# 323 N MAIN STREET – Window Replacement

## (25-69-COA)

CITY OF HENDERSONVILLE - COMMUNITY DEVELOPMENT - HISTORIC PRESERVATION  
COA STAFF REPORT

# 323 N MAIN STREET

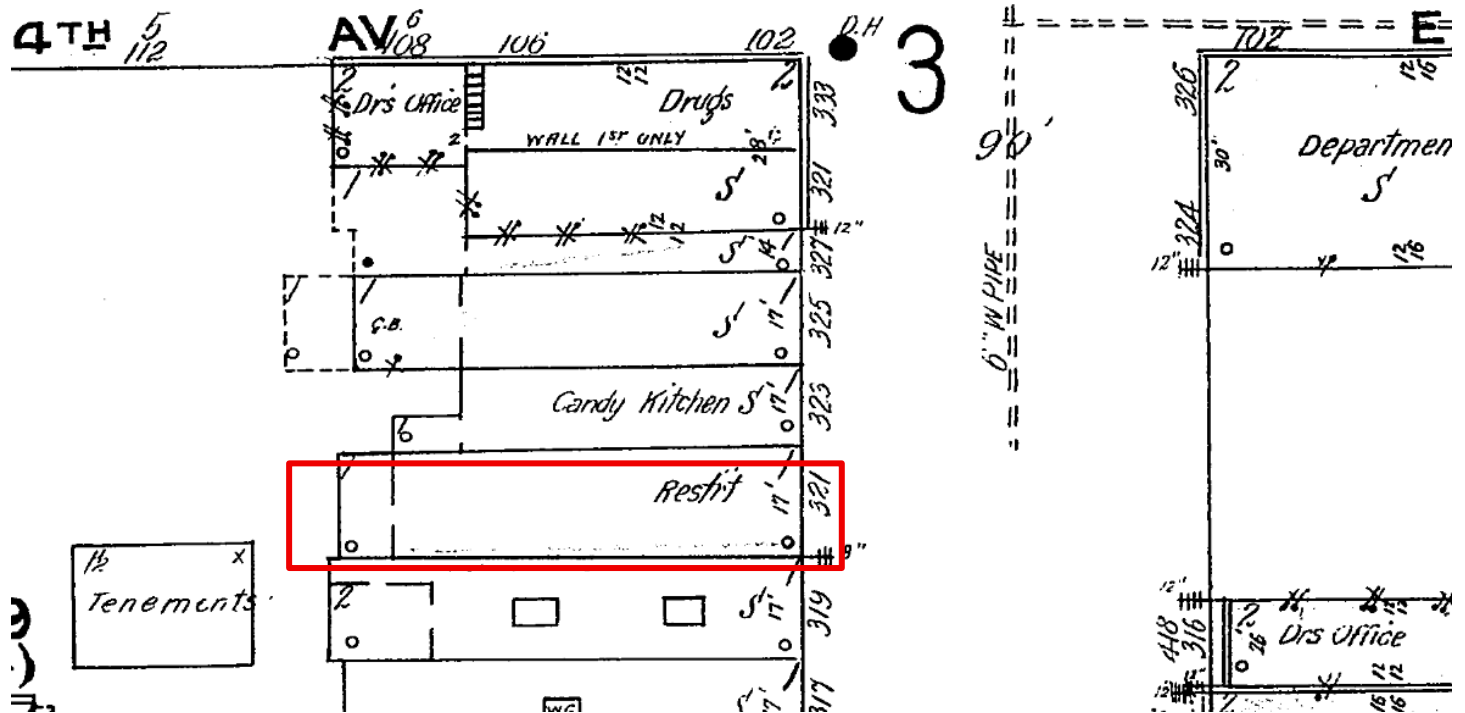
The applicant has proposed to replace ten windows on the north elevation of the building. The applicant's rationale for the need to replace the windows is grounded in the cost (which the commission is not legally allowed to consider), the delay that having the windows restored could cause for the project, and the need for storm windows to increase energy efficiency.

Staff met with the applicant in March 2025 to discuss the possibility of replacing the windows. Staff has the ability to approve second floor replacement windows on Main Street, however, staff determined that the windows were in good conditions and therefore could be restored. Because of this, staff would not approve the application for replacement windows, and therefore, the Commission must take up the actions. Staff recommended three window restoration specialists. The applicant has stated that they met with one of the restoration specialists and the restoration specialist has said it is possible to repair the windows.

The windows are situated on the northern elevation of the building and are partially obscured from the street. Staff will have further details and photos of this in their staff report during the meeting.
